THE MARYLAND-NATIONAL CAPITAL
PARK AND PLANNING COMMISSION

STAFF REPORT

SUBJECT: Preliminary Subdivision Plat 4-00010
Beech Tree, Phase 3

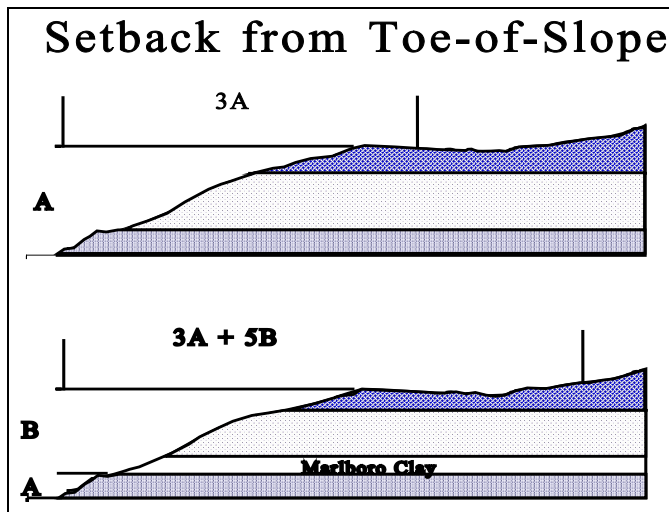
It has long been known that Marlboro Clay presents a special problem for development of this site. Consideration 6 of A-9763-C was adopted to address this issue. The greatest concern is the potential for large scale slope failure with damage to structures and infrastructure. Marlboro Clay creates a weak zone in the subsurface; areas adjacent to steep slopes have naturally occurring landslides. Grading in the vicinity of Marlboro Clay outcrops on steep slopes can increase the likelihood of a landslide. Water and sewer lines laid within the Marlboro Clay layer require special fittings. Side-slopes of road cut through Marlboro Clay need special treatment. Special stormwater management concerns need to be addressed when Marlboro Clay is present on a site.

Factor of Safety is a theoretical value: the ratio of Resisting Force to Driving Force. As the Resisting Force increases or the Driving Force decreases, Safety increases. As the Resisting Force decreases or the Driving Force increases, Safety decreases. The Prince George's County Department of Environmental Resources has set a minimum Factor of Safety of 1.5 for development near slopes affected by Marlboro Clay.

A High Risk Area presents a situation of danger to persons or property. A Low Risk Area presents no danger to persons or property. In large lot development, e.g., the R-A and O-S Zones, no development should occur in High Risk Areas, but such areas may occur within a lot. In small-lot development, i.e., lots with less than 40,000 square feet, no High Risk Area should occur on a lot.

The illustration indicating the potential Marlboro Clay outcrop pattern shows a High Risk Area computed by this model. Note that this area is based upon existing conditions. Grading can change the location of the risk area. Grading which removes material at the toe-of-slope or on a Marlboro Clay outcrop can aggravate the situation and cause the risk area to enlarge. Grading which adds material within the risk area above a Marlboro Clay outcrop can enlarge the risk area. Grading which removes material from above the Marlboro Clay can decrease the risk area.

The overall concept of the Comprehensive Design Plan is not affected by the presence of Marlboro Clay, but certain details are. The envelopes for Residential Uses, Public Facilities and structures (including roads) should be viewed as conceptual on the CDP and the Planning Board directed that a note appended on the CDP plan prior to signature certification:

- The envelopes shown on this plan are conceptual and may be modified at time of approval of the Specific Design Plan to minimize risks posed by Marlboro Clay. Prior to the approval of any SDP which contains a High Risk Area, a Geotechnical Study, following the *Criteria for Soil Investigations and Reports on the Presence and Affect of*
